SUBJECT: Forwards revised Relief Request RP-9 to permit use of ref curve for testing specific pumps (RHR, HPCS, LPCS & RCIC) instead of fixed ref point.

Subject: WNP-2, OPERATING LICENSE NPF-21
INSERVICE TESTING PROGRAM FOR
PUMPS AND VALVES (TAC NO. M60493)

RELIEF REQUEST NO. RP-9 (Revised May 17, 1993)

RHR-P-2A ACCEPTANCE CRITERIA

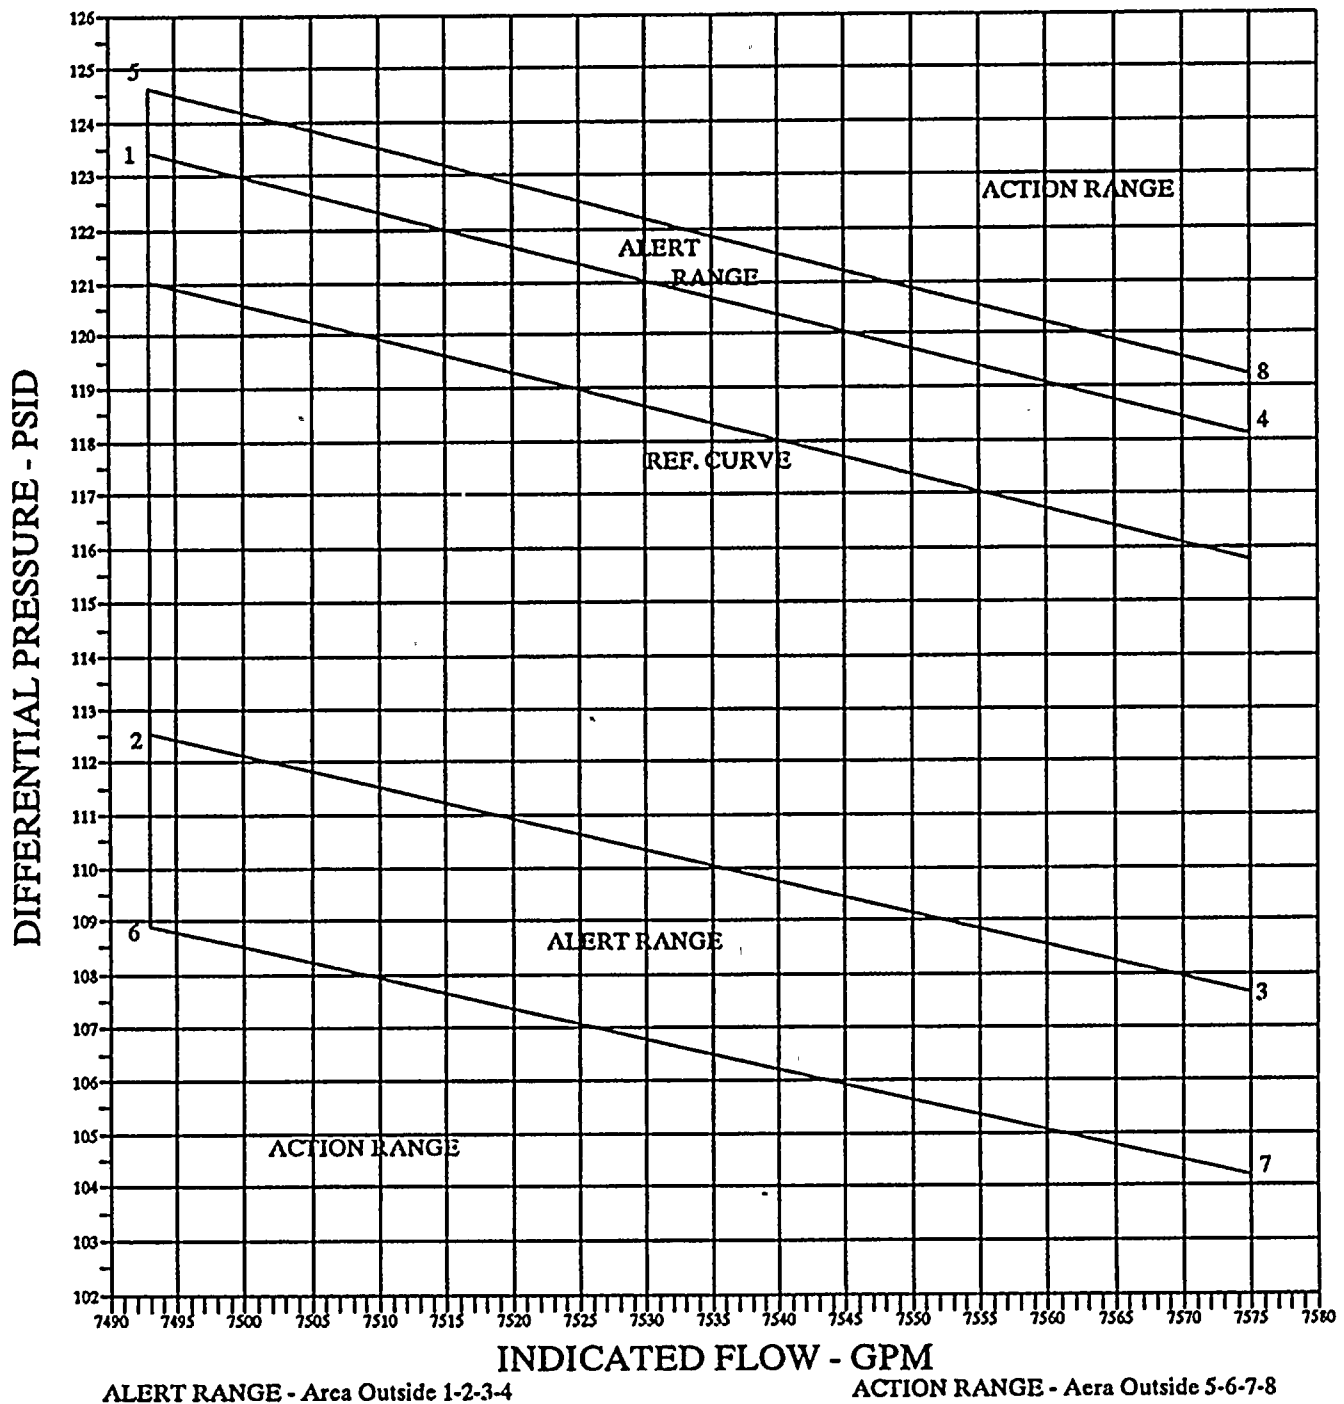
7. Acceptance criteria curves are based on differential pressure limits given in Table IWP-3100-2. See the attached sample RHR-P-2A pump Acceptance Criteria sheet. Area 1-2-3-4 is the acceptable range for pump performance. Areas outside 1-2-3-4 but within 5-6-7-8 define the Alert Range, and the areas outside 5-6-7-8 define the required Action Range. These acceptance criteria limits do not conflict with Technical Specifications or Final Safety Analysis Report operability criteria.
